UNITED STATES PATENT AND TRADEMARK OFFICE

APPLICATION NO.	FILING DATE	FIRST NAMED INVENTOR	ATTORNEY DOCKET NO.	CONFIRMATION NO.
10/649,441	08/26/2003	Mark V. Vanderwalle	5490-000313	5180

Office Action Summary	Application No.	Applicant(s)	
	10/649,441	VANDERWALLE, MARK V.	
	Examiner	Art Unit	
	Nicholas Woodall	3733

DETAILED ACTION

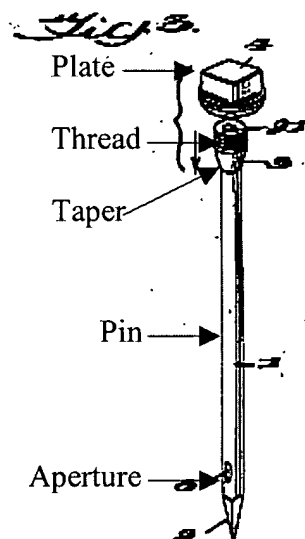
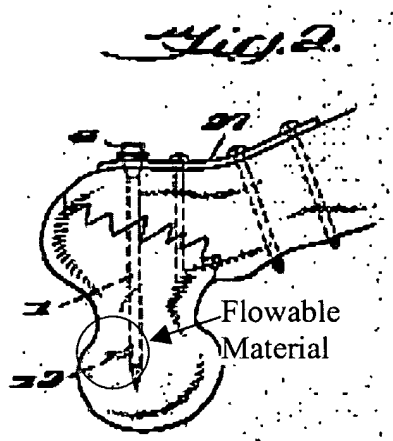
Regarding claims 1 and 2, Purificato discloses an implant system comprising a plate implant (4) and a pin implant (see figures 1 and 2 below). The characteristics of the pin implant include a distal portion (1) adapted to engage a section of bone. The pin also includes a proximal portion (3) adapted to engage the plate implant. The head of the pin implant is threaded (column 4 lines 48-53) for the purpose of engaging the internal thread of the plate implant (4). The pin implant contains a bore (5) that extends between the proximal portion and distal portion. The pin implant includes an aperture (8) to exterior of the implant. The bore (5) and the aperture (8) create a conduit through the pin implant. Regarding claim 3, Purificato discusses that the plate implant (4) has an internal thread that is complimentary to the threaded head portion of the pin implant (column 4 lines 48-53) and the two implants are connected as shown below in figure 3. Regarding claim 4, the pin implant is smooth and can be inserted into the bone by pounding the pin implant. Regarding claim 6, Purificato teaches that the pasasage (5) through the pin implant is capable of allowing a flowable material (10) to pass through the pin implant and out of the aperture (8) of the pin implant. Regarding claim 7, Purificato discusses that the aperture (8) of the pin implant is drilled at an angle to the longitudinal axis (column 3 lines 27-31). The angled aperture deflects the flowable material (10) out of the aperture and helps the flowable material operably interconnect to the bone. Regarding claim 8, in Purificato the flowable material (10) is added during the primary procedure after the pin implant has been set into the bone. Regarding claim

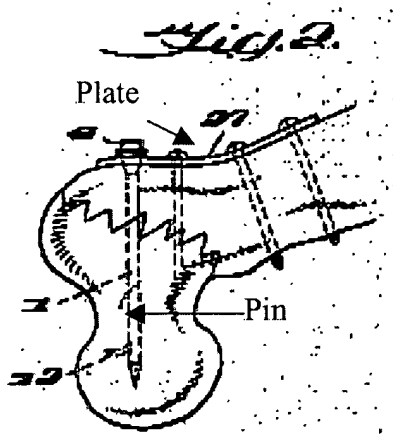
9, Purificato discusses a pin implant that is used for fixing a plate implant (4) relative to a selected portion of bone as shown in figure 3 below. The pin implant discussed includes a proximal section that can engage the plate implant (4). The pin also includes a bone engaging section (1) that extends from the plate engaging section of the pin implant. The pin implant also includes a bore (5) that allows a flowable material (10) to pass through the pin implant. The pin implant also includes an aperture (8) on the distal portion of the implant. The distal portion of the pin implant is capable of being passed into the bone. The bore (5) and aperture (8) allow a flowable material (10) to pass through the pin implant and operably engage the bone. Regarding claim 10, Purificato discusses the head (3) of the pin implant to include a thread that engages the internal thread of the plate implant (4). Regarding claim 11, Purificato indicates the pin implant may be made of any biocompatible material (column 2 lines 38-41). Regarding claim 12, Purificato shows a pin implant with a smooth distal portion (1), which allows the pin to easily pass through the bone. Regarding claim 13, the flowable material (10) is inserted through the pin implant during the primary procedure. Regarding claim 14, Purificato shows a tapered section as a lower portion of the head of the pin implant. Regarding claim 15, Purificato shows the aperture (8) located on the distal portion of the pin implant. Regarding claim 16, Purificato shows a bore (5) passing through the pin implant and substantially defines a cannula through the pin implant.

Regarding claim 17, Purificato teaches a method of fixing a plate implant (27) to a bone portion with a pin implant. Purificato inherently shows positioning the plate implant (27) relative to the selected bone portion, passing the pin implant relative to the plate implant (27), providing a conduit (5) through the pin implant to assist in fixing the pin implant, and flowing a flowable material (10) through the pin implant to interconnect

the pin implant with the bone as show in figure 2 below. Regarding claim 20, Purificato also shows selecting the pin implant to include a conduit that includes a bore (5) and an aperture (8). This conduit allows flowable material (10) to flow through the pin implant. The flowable material (10) exits the aperture (8) to interconnect the pin implant with the bone portion. Regarding claim 21, Purificato shows interconnecting the pin implant with the plate implant (27) to hold the plate implant (27) relative to the pin implant. Please reference figure 2 below. Regarding claim 23, Purificato shows a pin implant that can be passed into the bone by a pounding or driving force.

**Fig. 2**

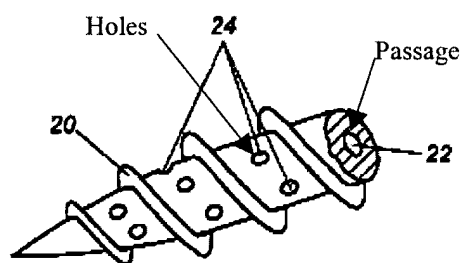
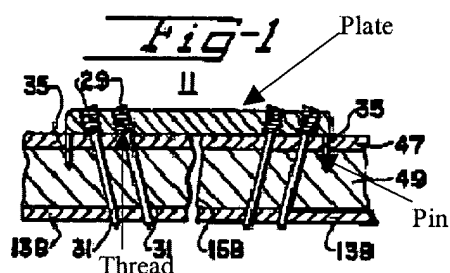
10. Claims 17 and 19-23 are rejected under 35 U.S.C. 103(a) as being unpatentable over Markolf (U.S. 3,741,205) in view of Chappius (U.S. 6,565,572). Markolf teaches a method of using a multiple piece implant system that fixes a plate implant relative to a bone portion with a pin implant. Markolf teaches positioning a plate implant (11) relative to a selected portion of bone. Markolf then teaches passing the pin implant (27) relative to a selected portion of the plate implant reference figure 1 below. Markolf also discusses the pin implant (27) having a threaded head (29) portion that is used to interconnect the pin implant (27) with a threaded bore (23, column 4 lines 16-28) of the plate implant (11). The pin implant of Markolf is smooth and can be driven into the bone without deteriorating the effected portion of bone (column 4 lines 28-32). Markolf fails to teach providing a conduit (e.g. bore and aperture) through the pin implant adapted to direct a flow of flowable material through the pin implant to enhance fixing the pin implant to the bone. Chappius teaches providing a passage (22) at least partially through the screw body (12) that join with holes (24) provided along the distal end of the

bone screw, which are adapted for dispensing medical adhesives, bonding cements, or other flowable materials as shown in figures 2 and 3 below (column 3 lines 49-59).

Chappius also teaches that the flowable materials create a firm fixation to the bone after curing and may strengthen the bone structure (column 4 lines 18-23). Therefore, it would have been obvious to one of ordinary skill in the art at the time the invention was made to construct the pin implant of the system discussed in Markolf with a conduit (e.g. bore and aperture) in view of Chappius to deliver a flowable material, such as bone cement, through the pin implant to the bone to help create a firm fixation between the pin implant and the bone.
